MANDATORY SERVICE BULLETIN

NO. MSB 42-088/3

This Service Bulletin prescribes the inspection of the joints that connect the MLG (main landing gear) damper with the MLG trailing arm for cracks.

WI-MSB 42-088

II.3 Material for replacement of MLG joints

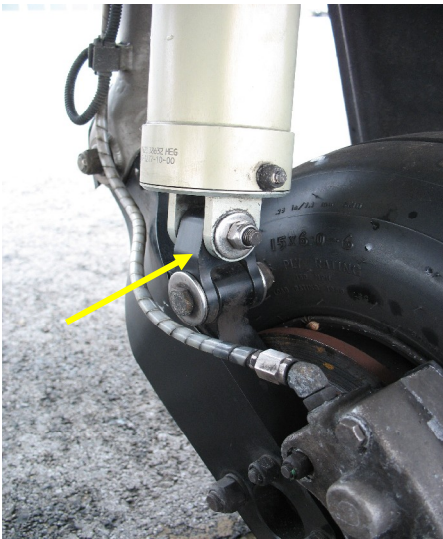
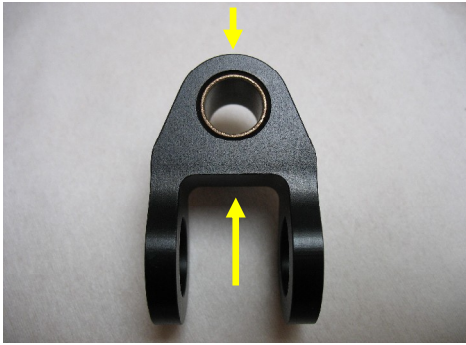
The MLG joint D60-3217-23-5x has been replaced by an improved design. Replacement of the MLG joint with the new design P/N D64-3217-23-0x (4 different lengths available) made of steel is described in this Service Bulletin. If MLG joint D64-3217-23-0x (4 different lengths available) is installed, no recurring inspection is necessary.

Quantity	Part No.	Description
2	D60-3217-25-00	Adapter bushing assy
2	D64-3217-21-62	Bushing
2	D64-3217-21-67	Bushing
a.r. *)	D64-3217-23-00	MLG cross joint assy Replacement part for D60-3217-23-51
a.r. *)	D64-3217-23-01	MLG cross joint assy oversize1 Replacement part for D60-3217-23-52
a.r. *)	D64-3217-23-02	MLG cross joint assy oversize2 Replacement part for D60-3217-23-53
a.r. *)	D64-3217-23-03	MLG cross joint assy oversize3 Replacement part for D60-3217-23-54
8	LN 9025-0815K	Washer M8
4	LN 9037-M8x50	Hexagon screw
4	LN 9338 M8	Hexagon nut
a.r	63830	Loctite 638

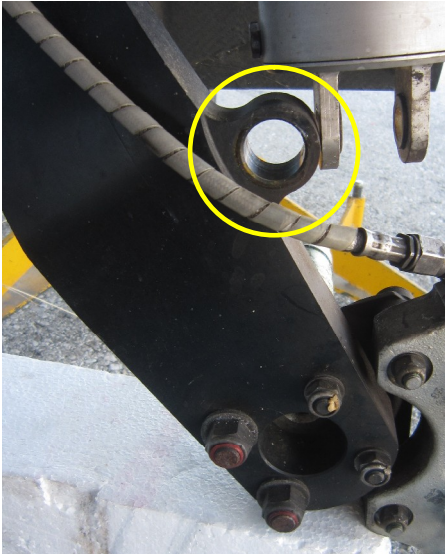
1	Insert AMM-TR-MÄM-42-447/a & AMM-TR-MÄM-42-452 and AMM-TR-MÄM-42-368 into the AMM or use an AMM revision into which these AMM-TRs have been incorporated.
2	<p>Remove the joint P/N D60-3217-23-5x (4 different lengths available) that connects the LH MLG damper and the LH MLG trailing arm. The joint is indicated in the picture. Refer to AMM, section 32-10.</p> <div data-bbox="632 703 1077 1240" data-label="Image"></div> <p data-bbox="794 1240 911 1272">Picture 1</p>
3	Clean the MLG joint.
4	<p>Examine the MLG joint for cracks.</p> <p>CAUTION: Look especially in the areas indicated by the arrows.</p> <div data-bbox="620 1516 1088 1859" data-label="Image"></div> <p data-bbox="794 1859 911 1890">Picture 2</p>
5	If cracks are found, replace the MLG joint i.a.w. Section III.2. Otherwise reinstall MLG Joint.
